REQUEST FOR TECHNICAL REVISION (TR) COVER SHEET

Backup Information
Request for Technical Revision – Relocation of Surface Water Monitoring Locations CC-1 and TC-2
Parkdale Quarry
Reclamation Permit M-1997-054
Fremont County, Colorado

Figure 1 - CC-1 Relocation

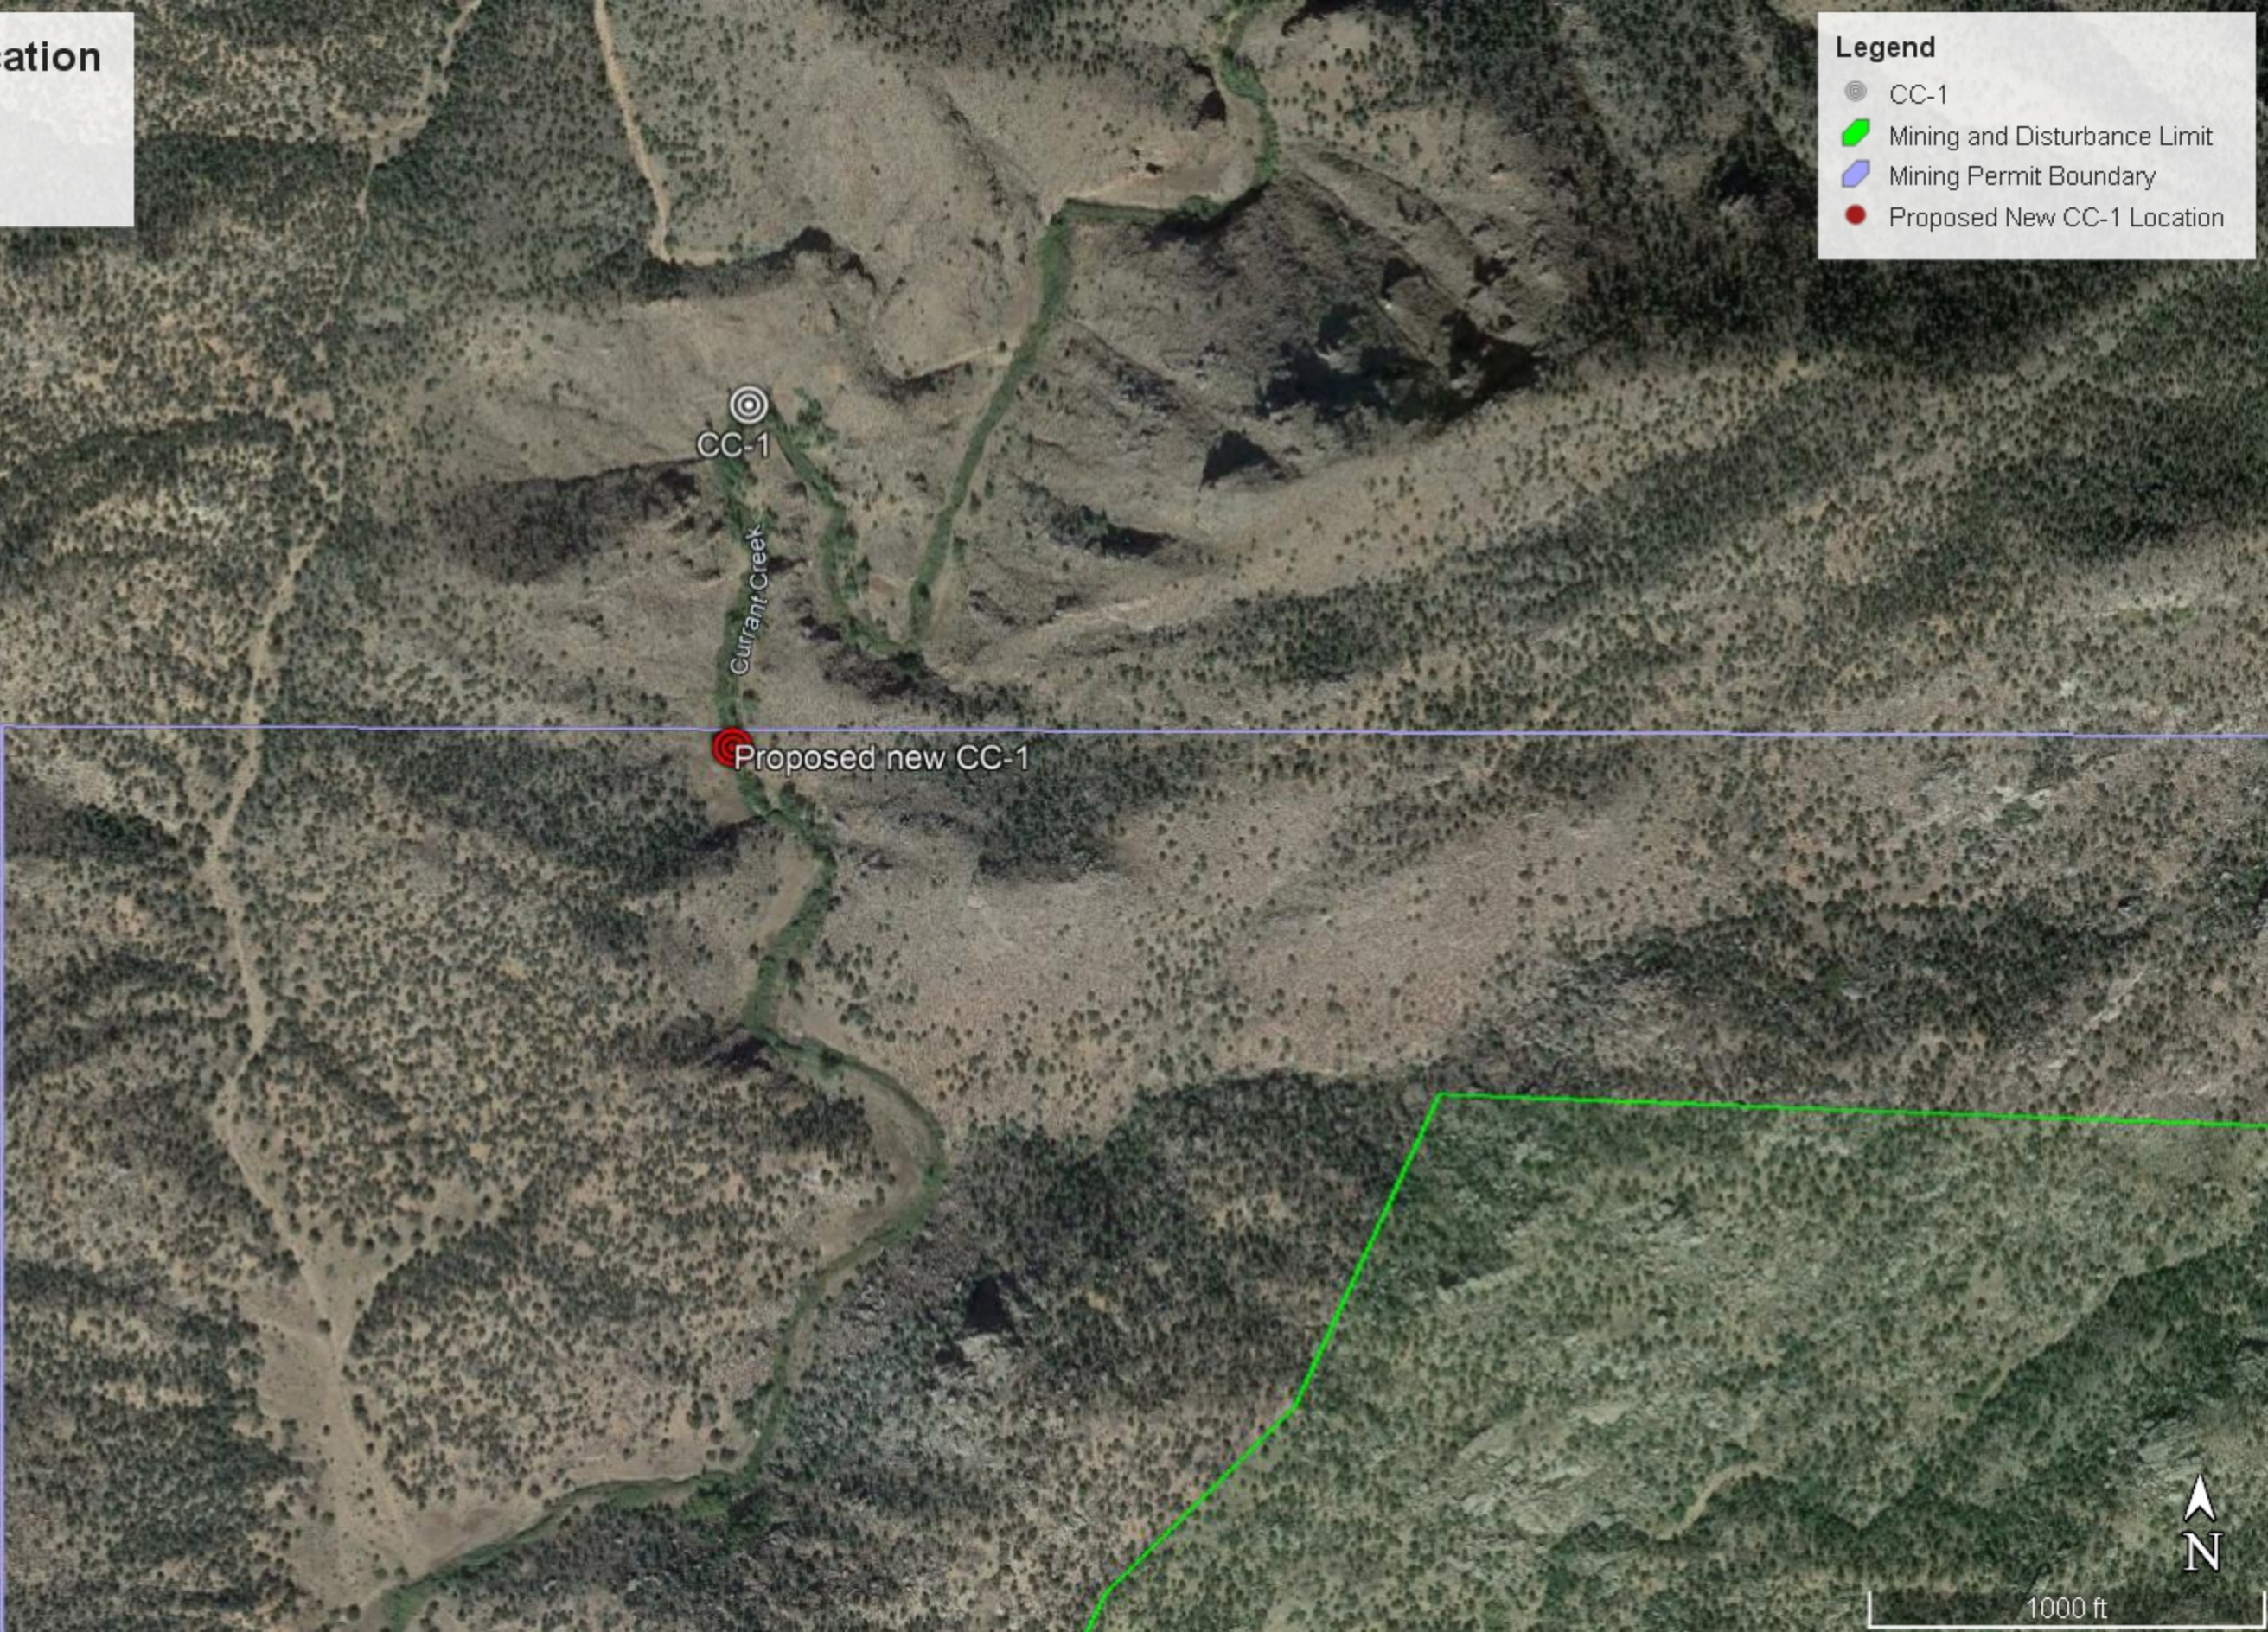
Front Range Aggregates proposes to move the upstream monitoring point on Currant Creek, CC-1, south, but still up gradient from the mining area as shown on the appended aerial Figure 1. Moving CC-1, as proposed, will allow safer access for on-going surface water monitoring and sampling, especially in winter and spring, as well as keeping all activities within the Colorado Department of Reclamation, Mining and Safety (DRMS) mining permit boundary and within Front Range Aggregate's Bureau of Land Management Mineral Materials Contract lease boundary.
